W. PASCO CLASS I (SW2 & A3), [REDACTED]
(camera misdated) 12/18/01
PASCO COUNTY SIS, KBF

From: Ford, Kim
Sent: Friday, October 12, 2001 10:19 AM
To: Butera, Robert
Subject: Comments on the recent W. Pasco revised draft certification

Subject: West Pasco County Landfill Operation Plan

Figure 2B

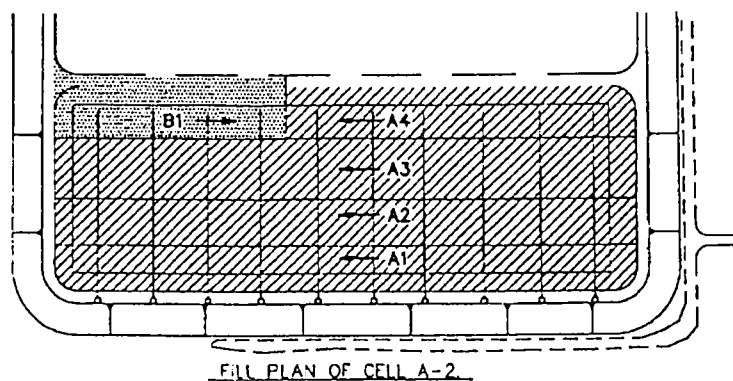
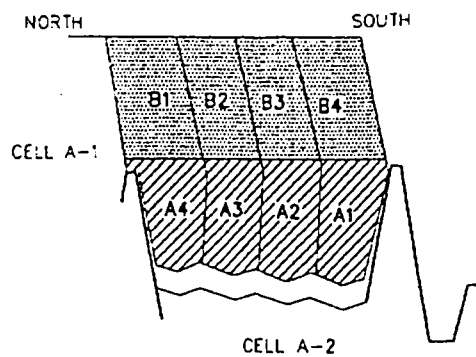
FIGURE 2B IN THE 6/11/01 OPERATIONAL PLAN SUBMITTAL IS INCORRECT
THE CORRECT FIGURE IS THE FIGURE PREVIOUSLY IDENTIFIED AS
FIGURE 8.2B

Figure 2B

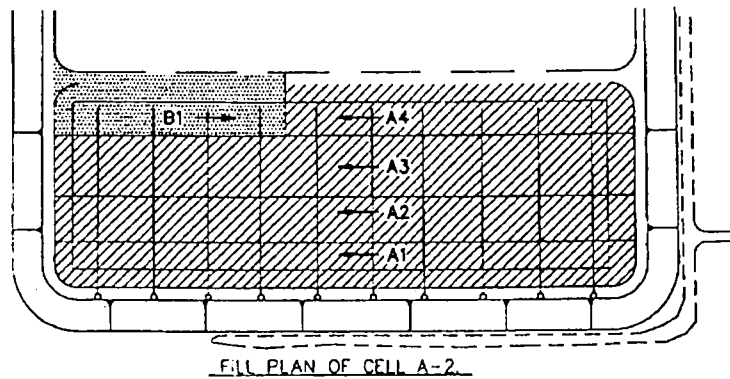
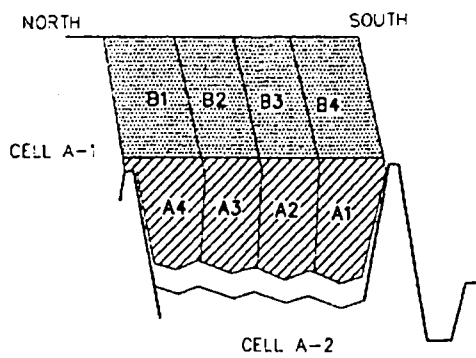
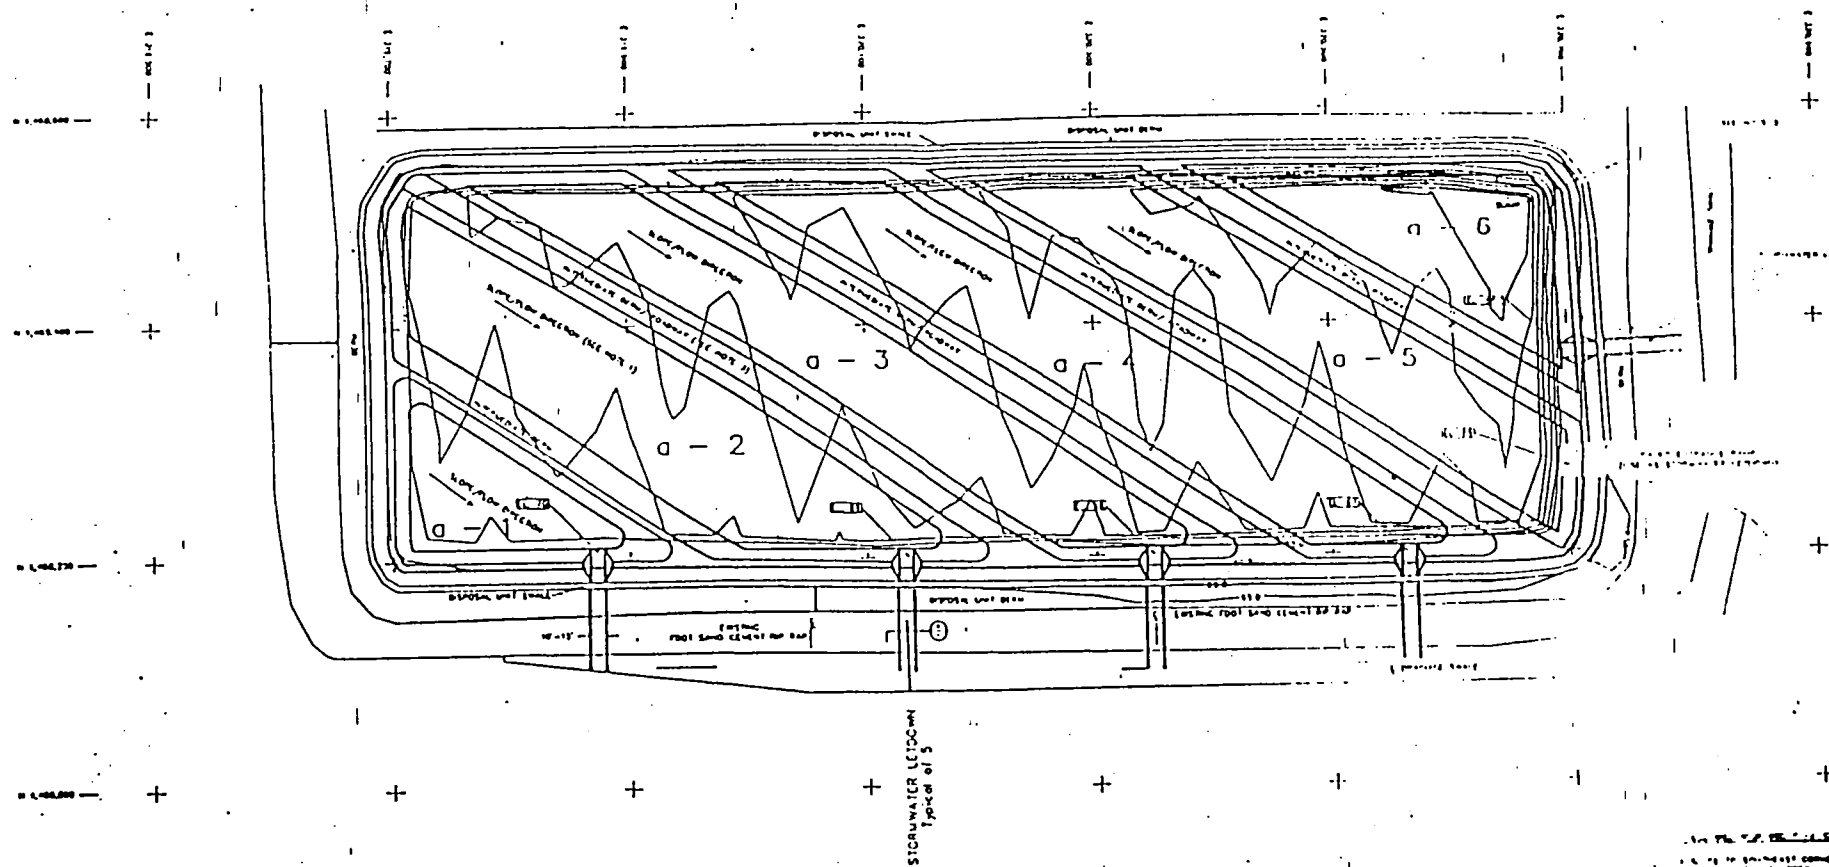
FIGURE 2B IN THE 6/11/01 OPERATING PLAN SUBMITTAL IS INCORRECT
THE CORRECT FIGURE IS THE FIGURE PREVIOUSLY IDENTIFIED AS
FIGURE 8.2B

Transmitted, herewith, is a revised Figure 2B for the West Pasco Landfill Operations Plan. Please remove the existing Figure 2B and replace it with the attached.

DETAIL

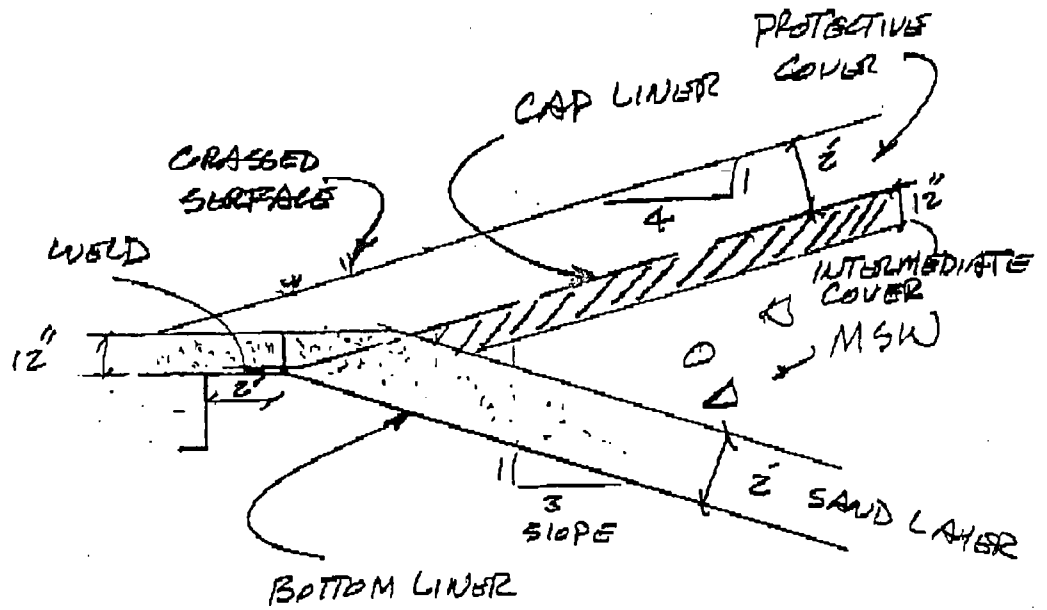
3. The reclaimed water line is not tied to the leachate transport line. (See Detail C on Sheet M-1).
4. The purpose of the washdown stations is to provide a source of water for irrigation, and to washdown equipment and trucks, as necessary. Washdown activities will take place only on the area within the lined cells to eliminate washdown water discharge into surface drainage. This will be addressed in the Operational Plan, which will be prepared and submitted to FDEP prior to operation of the new cells.
